**From:** "Suttora, Linda" <Linda.Suttora@em.doe.gov>  
**To:** "Ryan Whited" <ARW2@nrc.gov>, "Xiaosong Yin" <XXY@nrc.gov>  
**Date:** 07/19/2006 3:45:30 PM  
**Subject:** Remainder of Idaho TFF information

Attached are the four final documents requested during the June 1 and June 20, 2006 meetings. This fulfills DOE technical information requested by your organization for the Idaho Tank Farm Facility Waste Determination.

## Analysis of Delayed $^{90}\text{Sr}$ Release from the Grouted Vault and Sandpad

### Follow-up Item from June 1 and 20, 2006, Meetings with DOE on INL TFF Waste Determination

Figure 1. Location of groundwater concentration zone locations.

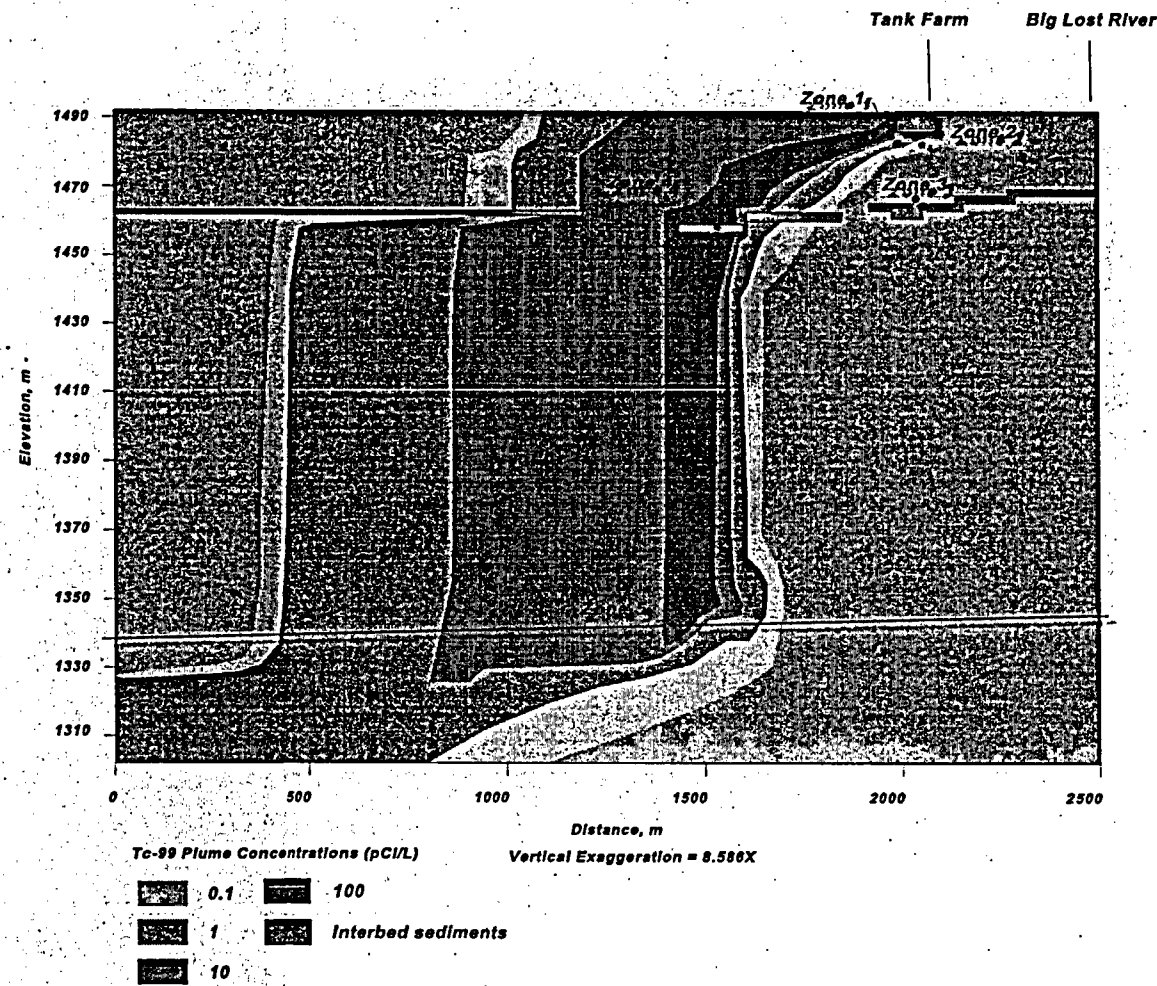
DOE-ID should provide center-line plume concentrations (as depicted in Figure 4-2 of the PA) as a function of time for modeled radionuclides at key locations in table format and a figure showing these locations. Locations should include the following grid cells: 1.) directly underneath the TFF in the perched water, 2.) near the "spillway" in the perched water, and 3.) in the saturated zone. DOE-ID revised the time of peak release for Tc-99 in Table 4-1 of the PA in response to RAI #13. The source of the error described in the RAI response is not clear. Furthermore, the travel time to saturated groundwater is difficult to determine with the use of scientific notation which truncates the year of maximum concentration in groundwater for Tc-99 (DOE-ID should provide the travel time in years). The information requested above is also needed to clarify to what extent Sr-90 concentrations are reduced due to attenuation in the 600 meters of lateral transport in the unsaturated zone, which cannot be determined easily from the currently available information.

DOE is providing groundwater concentrations at the five zone locations identified in Figure 1. The groundwater concentrations (Ci/m<sup>3</sup>) are provided based on a unit Ci release from the tanks and sandpads for <sup>129</sup>I, <sup>99</sup>Tc, and <sup>90</sup>Sr in Tables 1 through 6 and Figures 2 through 7.

Figure 1. Pressure profile for the TFF PA groundwater domain.

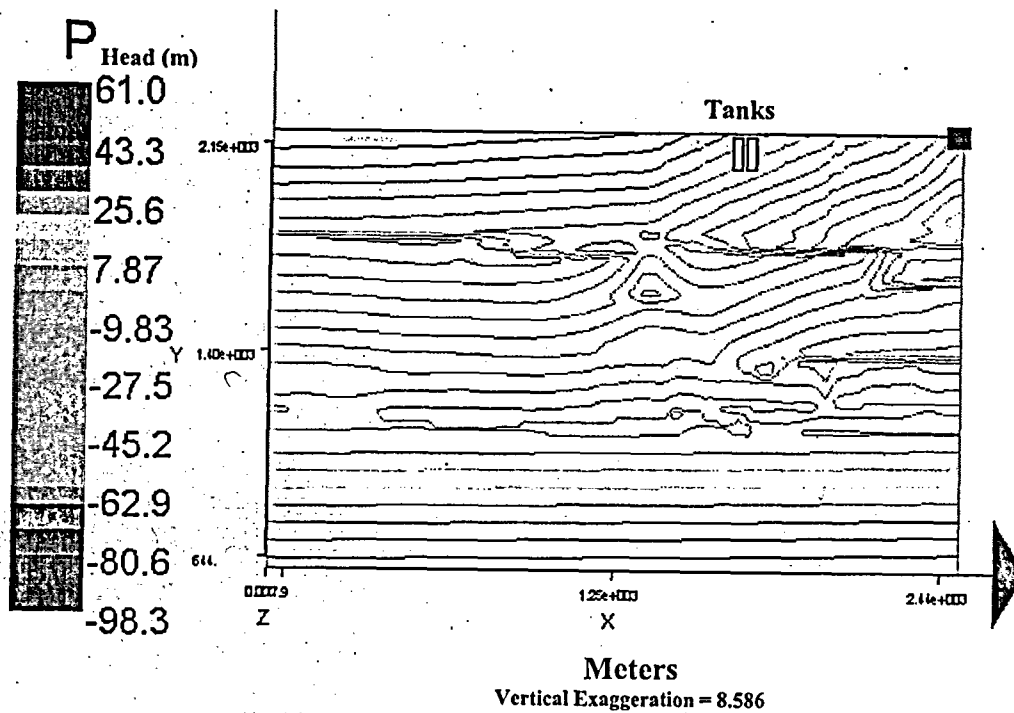
DOE-ID should try to provide a better explanation regarding the large lateral extent (0.5-1 mile) of the contaminant plume near-surface and as it enters the saturated zone. For example, is the large lateral extent near-surface indicative of perched water in the alluvium? DOE-ID should also explain why the contaminant plume is depicted at the surface of the model domain in Figure 4-2 of the PA when the tanks are located at approximately 45 feet below grade.

The explanation regarding the large lateral extent of the contaminant plume near surface is due completely to the pressure gradient that results from the steady-state infiltration boundary condition for the Big Lost River. The large lateral extent of the contaminant plume is not indicative of perched water in the alluvium.

Figure 1 provides the pressure gradient in the model domain, while Figure 2 presents the corresponding saturation values for the model domain. Since an average infiltration rate was used for the Big Lost River in the long-term analysis, pressures and low permeable units with variable saturation levels exist in the modeling domain. This modeling system results in contaminant migration laterally away from the Big Lost River until pressure and gravity components reach a state where vertical flow is possible.

Figure 1. Extent and depth of perched water bodies with percolation ponds in service.

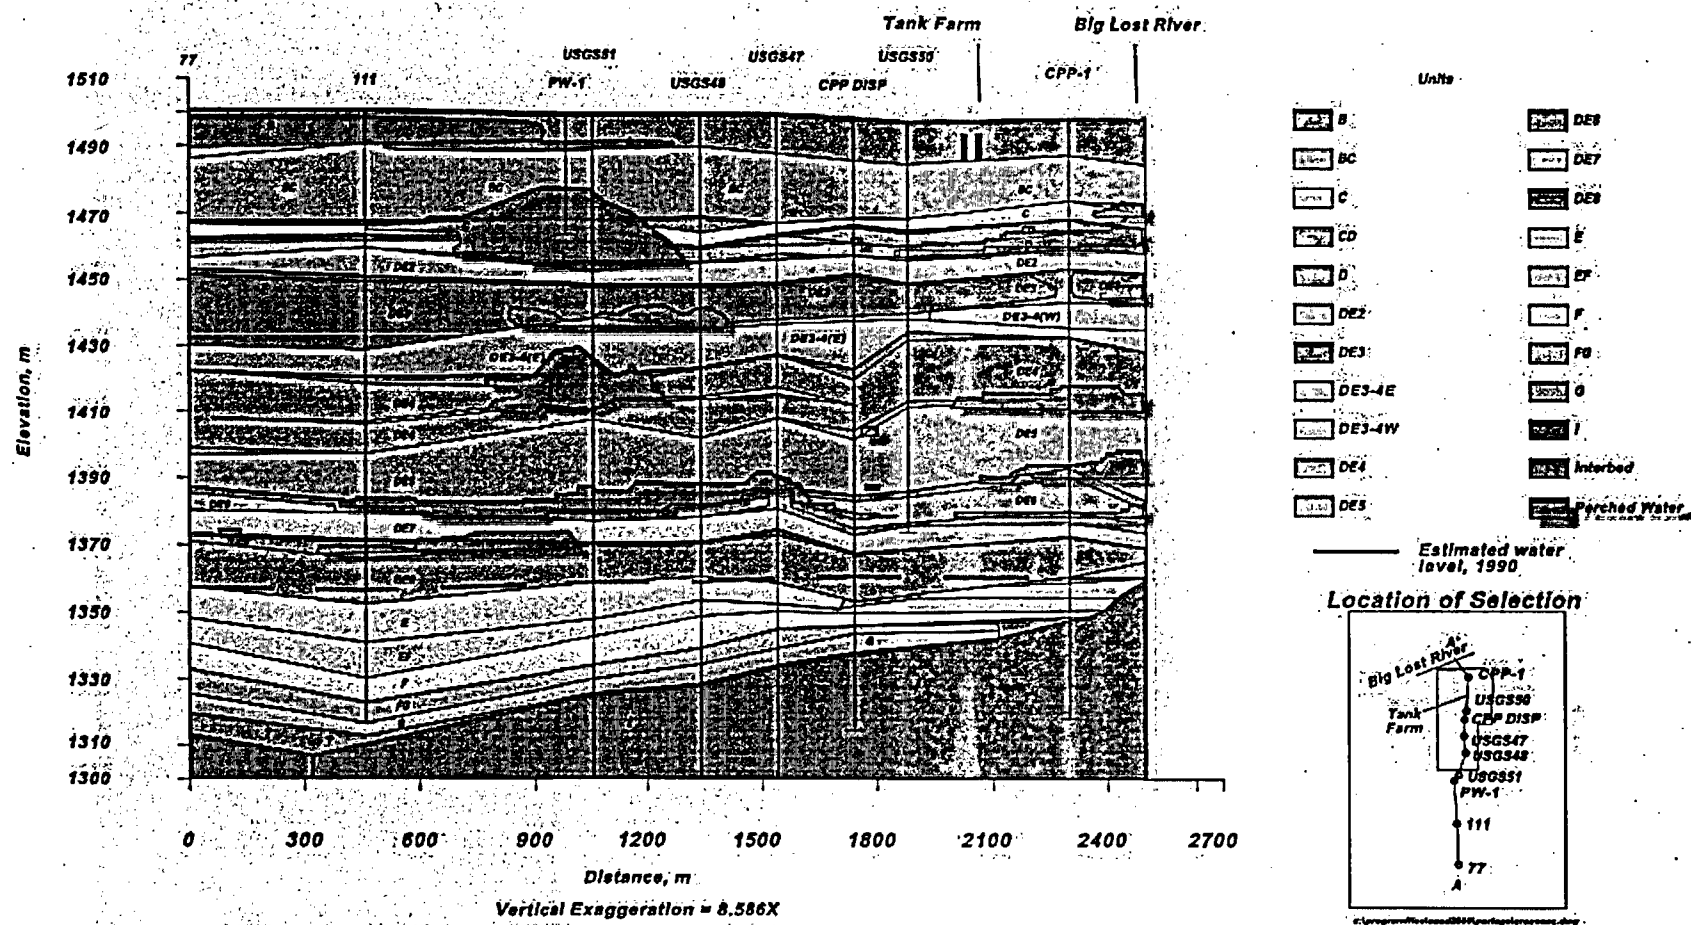
DOE-ID should provide the approximate thickness and extent of perched zones in the final calibrated model in plan view along the cross-section, final calibrated heads at nearby monitoring well locations, and the hydrostratigraphic location of the top of the perched zones. Based on new information that shows the HCM for vadose zone flow at TFF has evolved based on collection of additional characterization data (ICP/EXT-04-0244), NRC needs additional information to determine the goodness of fit of the modeled versus observed heads, to determine the amount of dilution in the perched zones, and to estimate the magnitude of attenuation during lateral transport along the perched zone.

NRC has requested that DOE provide a plan view map of the perched water bodies along the modeled cross-section. However, the model is two-dimensional, thus preventing any meaningful information in plan view. DOE is providing scaled figures in the modeled cross-section from which the requested information can be measured.

Figure 1 provides the thickness and extent of the perched water zones for the calibration of the model based on the percolation ponds. To calibrate the development of perched groundwater zones caused by seepage from the Big Lost River and the percolation ponds, Table 1 (Table 3-7 in the PA) lists the available monitoring wells, including surface elevations, well depths, screen intervals, and water level elevations.
